CS Memorandum No. 1328

Subject: Configuration Management Board Meeting No. 107

CMB Meeting Minutes #107

SUBJECT: Configuration Management Board Meeting # 107 – Rev. No. 0

UTILITY DEMOLITION
FOURTH STREET PORTAL
CTL 163+25 TO 165+50

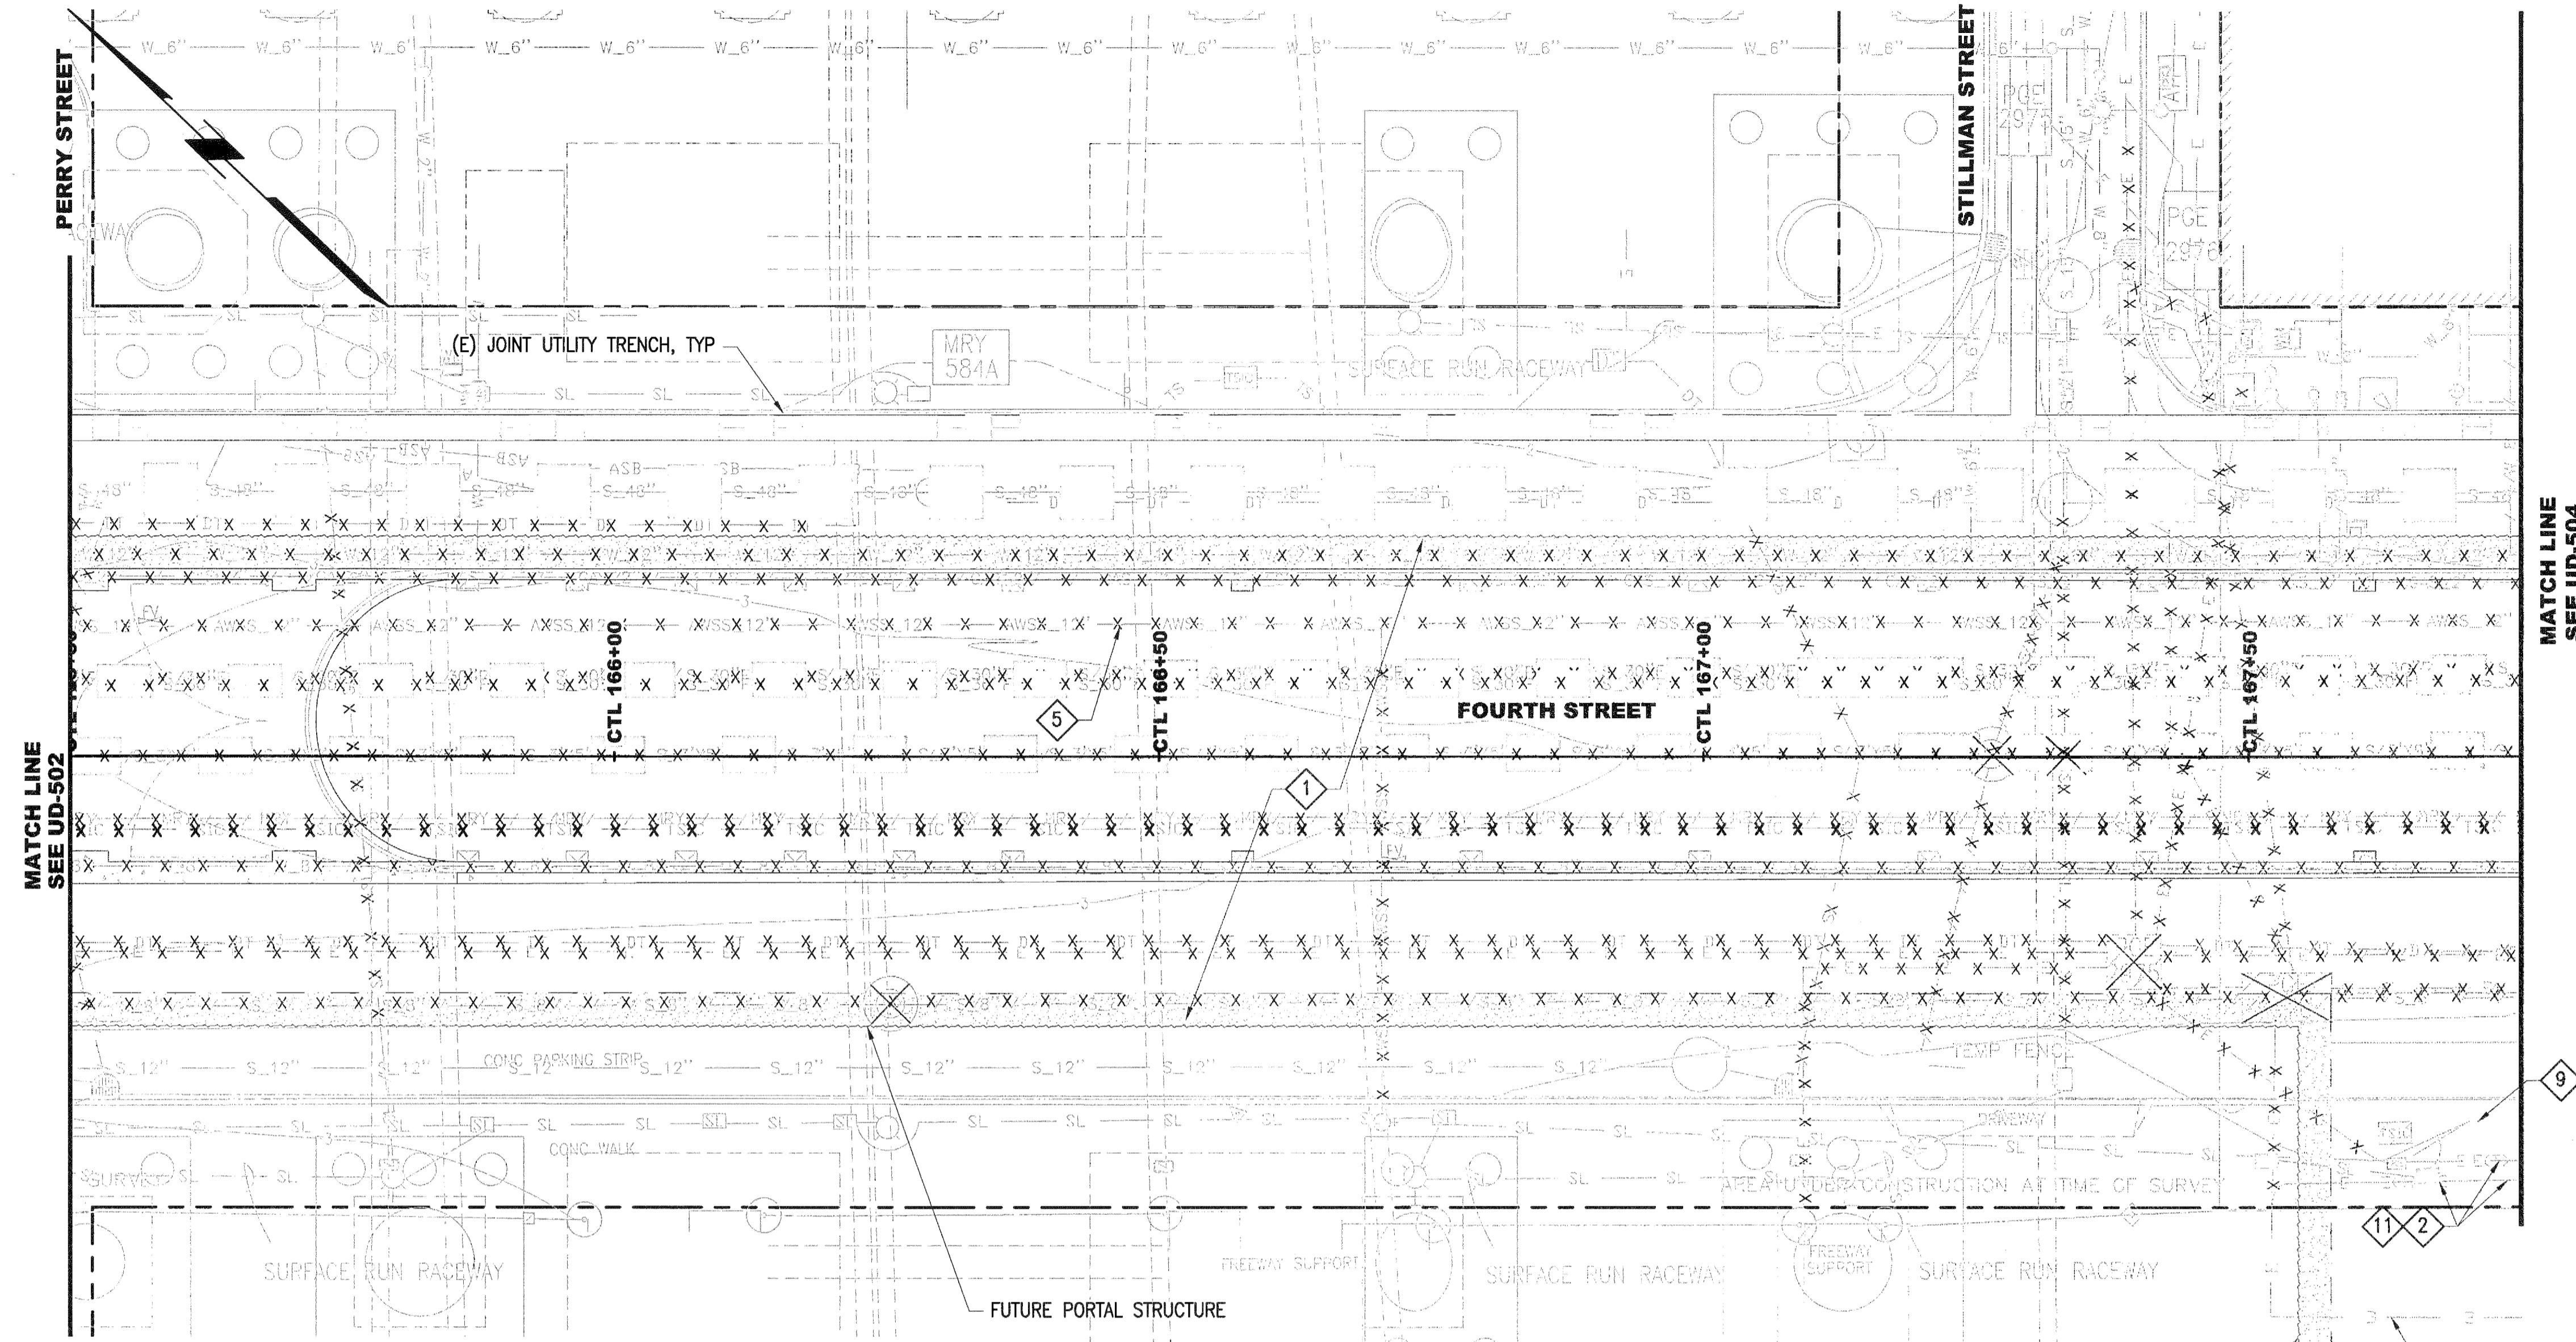
1252-0004	04/06/12	PG&E live electrical delays	2						+8,295	PG&E lines indicated on contract drawing UD-502 thru 504 were to be abandoned yet were Re reviewing COR		
1252-0005	06/12/12	Oil filled pipe @ Launch Box	2						+9,979	Synergy Demo Crew exposed an existing 6" steel line which had oil in it on the West side of 4th St between Harrison and Bryant. RE to prepare mod		
1252-0006	07/16/12	TIA - Associated w/ COR 001, COR 002, and COR 003	6						+269,904	BIH is to submit Overhead cost labor rates and a COR request related to this issue. RE reviewing COR		
1252-0007	05/23/12	MOS - Live Utilities: PGE, AT&T, and SFWD 8" Water Line extra kill hole location	2						+49,006	Live PG&E Electrical Lines Conflict: BIH was notified that PG&E had live electrical lines running through each headwall work zone @ Moscone station. 8 inch Low Pressure Water Line Conflict: Contract drawings show this utility to be abandoned and capped prior to work. Synergy struck and damaged the water line. SFWD directed Synergy to excavate a kill hole so they could properly abandon the line. In Review

EXHIBIT "A"

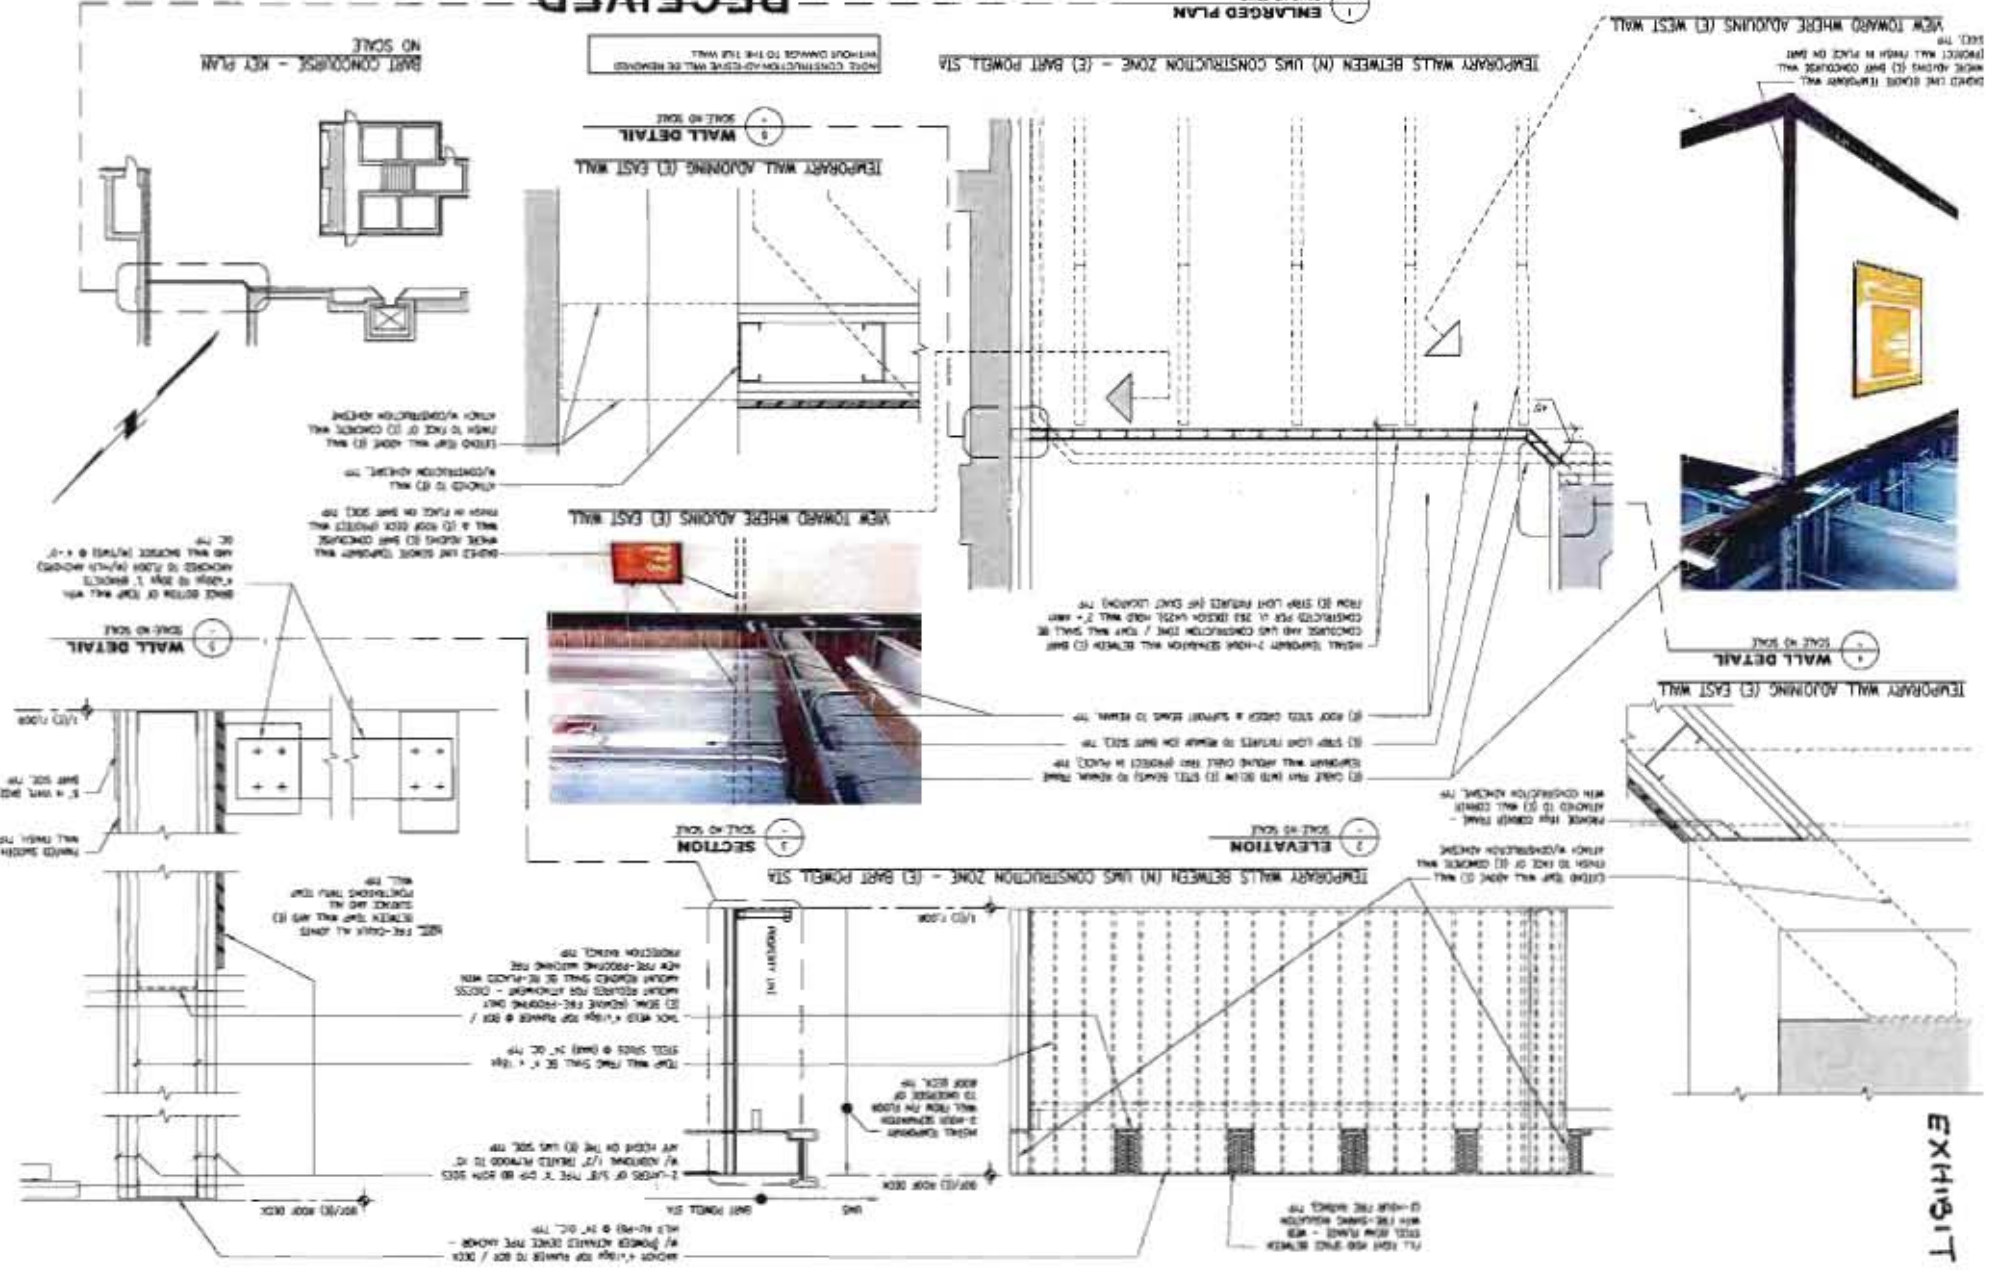
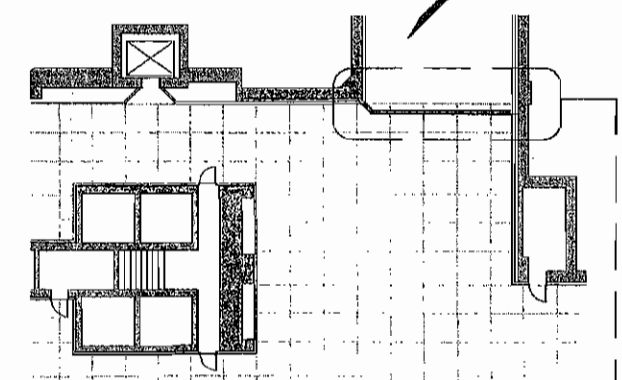
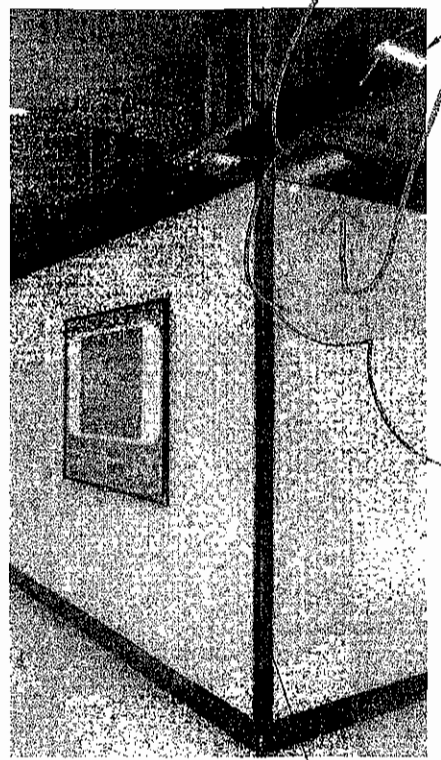
2-	1252 - J. Wang presented PCC 07 for Tunnels – BART Annex Wall. The proposed change request the Contractor to construct a temporary 2-hour fire rated wall at the BART Ellis Street entrance, consisting of 5/8" sheet rock (both sides) and cover with 1/2" fire treated plywood on the SFMTA side between the Powell Street Station and the future UMS Station (see attached PCC 07). The CMB concurred with the proposed contract change and directed the RE to submit the documentation to the Contractor requesting a price quote to perform the work.	
3-	1252 - S. Wilson presented PCC 008 for Tunnels – UMS Tree Removal. In accordance with spec sec. 32 90 05 03 Stump Removal. The RE requested a lump sum cost from the Contractor for tree and stump removal at the northeast corner of Stockton and O'Farrell Streets to a depth of 6" below grade. The Contractor priced the work at \$12K. The CMB was in agreement that the price received from the Contractor was too high and directed the RE to discuss with A. Clifford (PM/CM) his recommendation of which certified tree removal companies contacted by him would be best suited to perform the work. In addition the permit issued by DPW – Bureau of Urban Forestry requires the work be performed by January 12, 2013. Direction was also given to the RE to revise the text "Certified Arborist is required, which is not the case. This item will be brought back to the CMB at a later date.	S. Wilson 01/09/13

What (Description of PCC) BART Annex Wall
Why (Reason for Requesting PCC) The Powell Street Station Ellis Street entrance, currently known as BART Entrance R, is necessary for UMS egress purposes. As condition for the purchase of Entrance R property from BART, a fire separation is required between the Powell Street Station and the planned Union Square/Market Street Station. This Temporary Wall fulfills this requirement until the UMS construction is complete with the installation of and fully operable permanent roll-down fire door and grille door.
Where (Location, Station) Powell Street Station – Ellis Entrance (Entrance R)
When (Occurrence date, action date, potential time impact) Install Wall by mid-January 2013.
How (Recommendation of Action) Utilize Contract 1252 to install the Temporary Wall
Estimate (Summary of Engineer's Estimate w/EE attached) TBD
Drawing Exhibit A

4.d Permittee shall install a 2-hour fire rated temporary wall with steel studs (Max. 24" O. C.). Wall shall be constructed of 5/8" sheet rock (both sides) and covered with 1/2" fire treated plywood on the SFMTA side, fire taped finished and painted white on the Powell Street Station side and fire taped on the SFMTA side. No doors are allowed in the wall. Existing wall tiles and floor finish shall be protected against any damage.

Approx.
Location
TREE No. 160

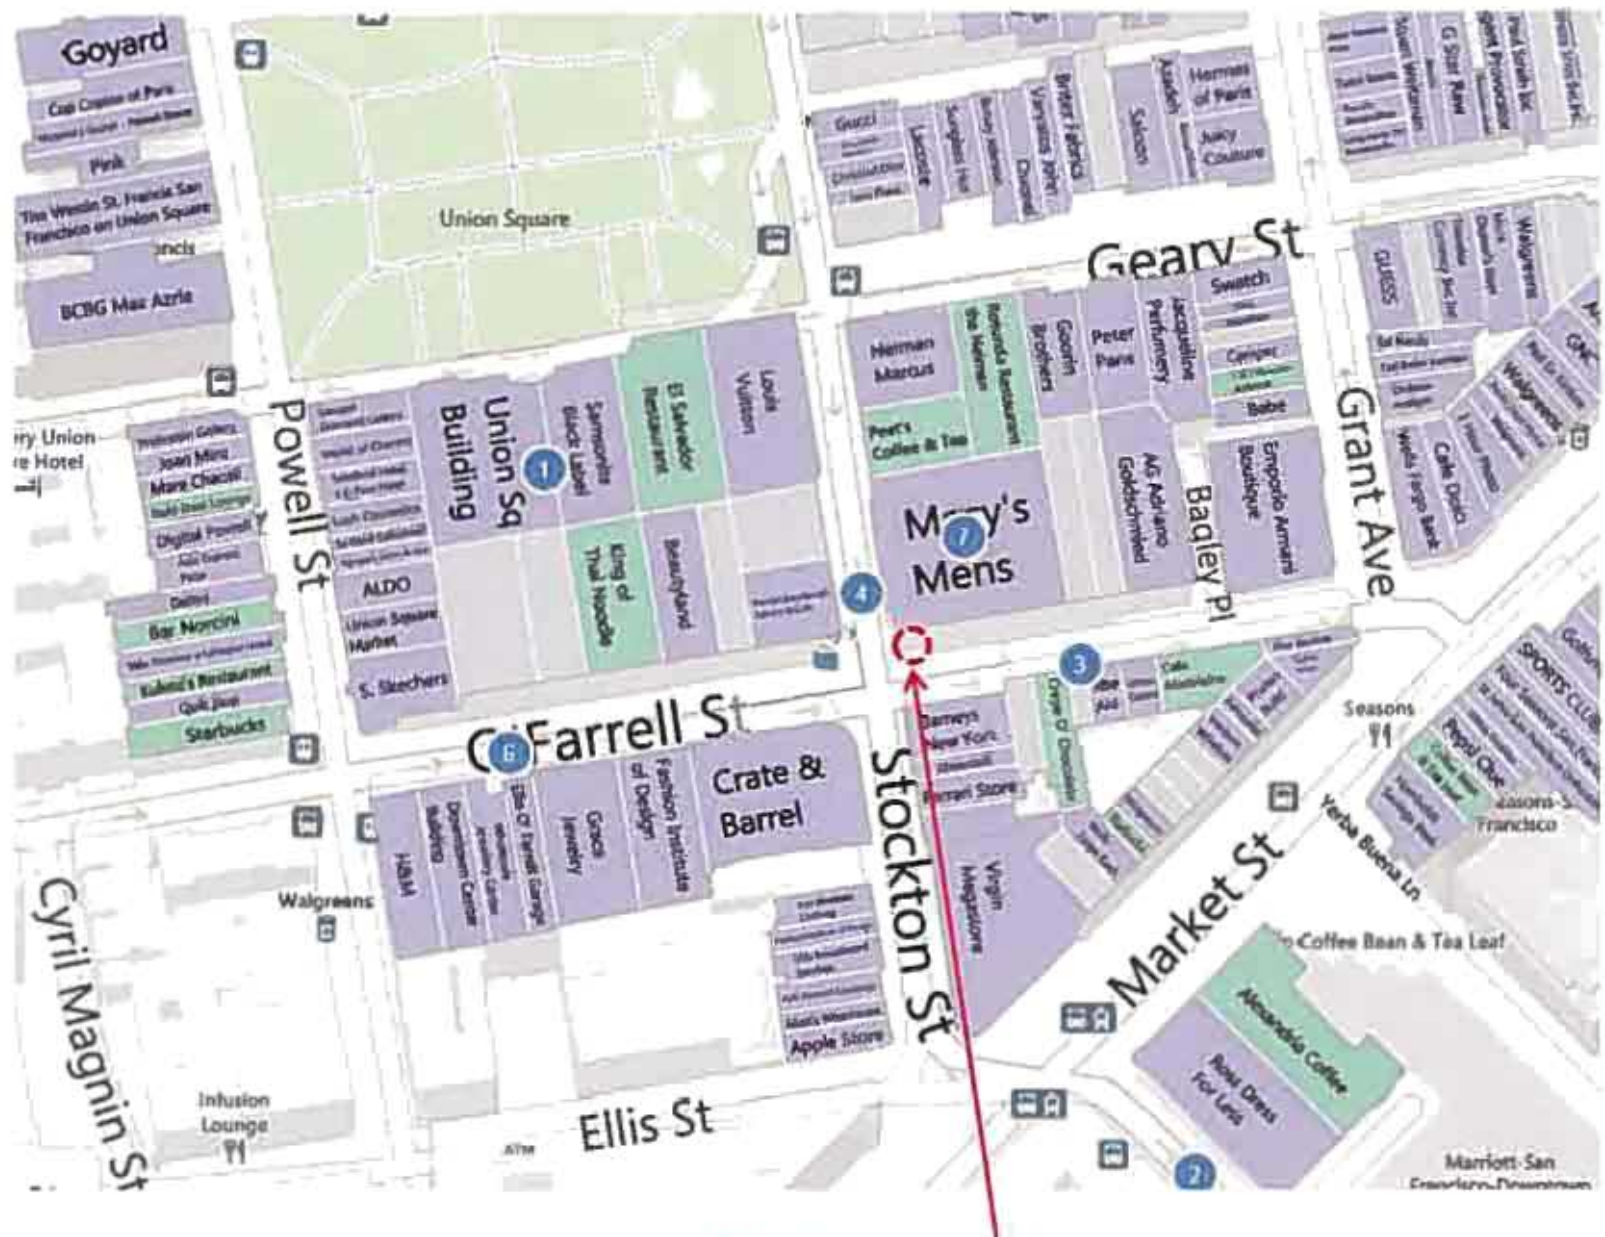
- Remove tree and stump at the northeast corner of Stockton and O'Farrell Streets (see attach. No.1) to a depth of 6" below grade.
- Finish grade and bark mulch shall match adjacent planting areas.

BIH is directed to remove the tree and stump up to a depth of 6". The finish grade and bark mulch shall match adjacent planting areas.
